ArevaEPRDCPEm Resource

Request for Additional Information No. 351, Supplement 2

U.S. EPR Standard Design Certification
AREVA NP Inc.
Docket No. 52-020
SRP Section: 09.02.05 - Ultimate Heat Sink
SRP Section: 09.05.01 - Fire Protection Program

Question 09.02.05-22:

Figure 2.7.11-1—Essential Service Water System Functional Arrangement
Sheet 1 of 9

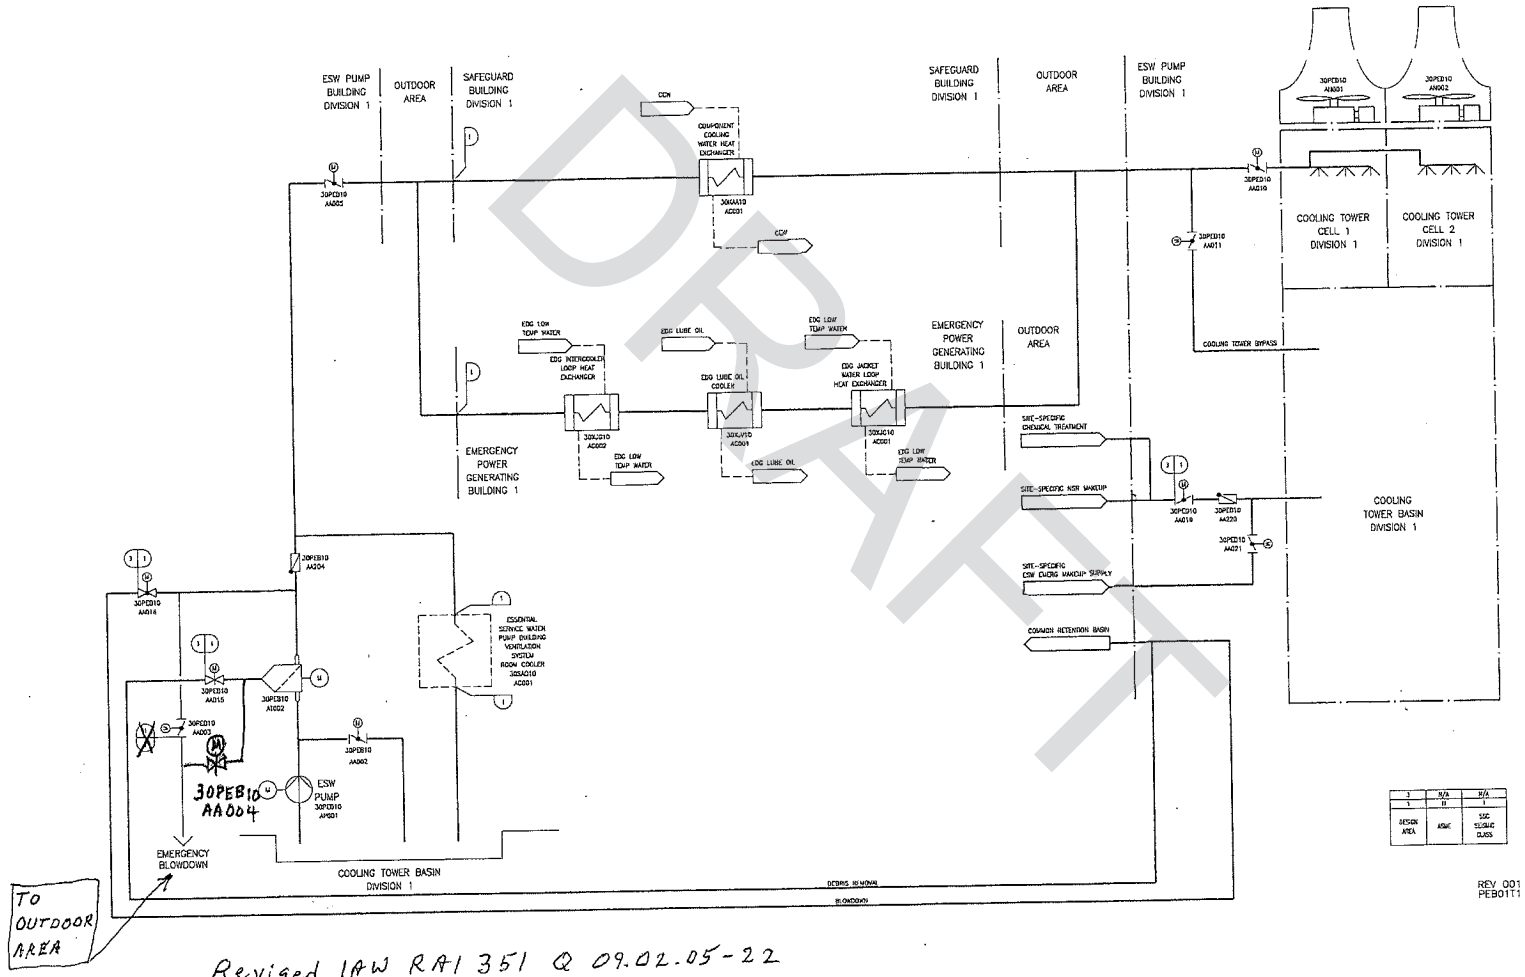
The ultimate heat sink (UHS) must be able to withstand natural phenomena without the loss of function in accordance with General Design Criteria (GDC) 2 requirements. The system description does not explain the functioning and maximum allowed combined seat leakage of safety-related boundary isolation valves at the UHS basin to ensure UHS integrity and operability during seismic events and other natural phenomena. Consequently, additional information needs to be included in Tier 2 Section 9.2.5 of the Final Safety Analysis Report (FSAR) to fully describe: (a) the assurance of UHS integrity and operability by the safety-related boundary isolation valves so that common-cause simultaneous failure of all non-safety-related UHS piping will not compromise the UHS safety functions during seismic events, (b) provide the maximum allowed combined seat leakage that assures that the safety-related UHS boundary isolation valves and periodic testing that will be performed to ensure that the specified limit will not be exceeded, and (c) a description of any other performance assumptions that pertain to the boundary isolation valves or other parts of the system including blowdown that are necessary to assure the capability of the UHS to perform its safety functions during natural phenomena. In addition, under FSAR, Section 9.2.5.5, "Safety Evaluation," it states that "The UHS pump buildings and cooling towers are designed to withstand the effects of earthquakes, tornadoes, hurricanes, floods, external missiles and other natural phenomena." However, there is no mention of the piping system being designed to meeting these conditions.

The applicant response indicates that non-safety-related system piping is seismically analyzed for adverse interaction with safety-related structures, systems, and components and refers to FSAR Tier 2, Section 3.7.3.8, for additional information. However, the response did not address the effects of flooding due to failure of non-safety-related piping associated with the essential service water system and the ultimate heat sink, and additional information is needed to assure that the consequences of flooding in this regard will not pose a threat to safety-related equipment. Additionally, since the blowdown piping for the cooling tower basins is non-safety-related, the effects of cooling tower basin overflow due to torrential rains and hurricanes need to be addressed. The FSAR should be revised to include this information as appropriate.

To ensure the function of the safety related filter, an alternate filter blowdown is provided as shown in the FSAR Figure 9.2.1-1 being revised. The new line includes valve 30PEB10/20/30/40AA004, Filter Emergency Blowdown Isolation Valve.

Revised IAW RAI 351 Q 09.02.05-22
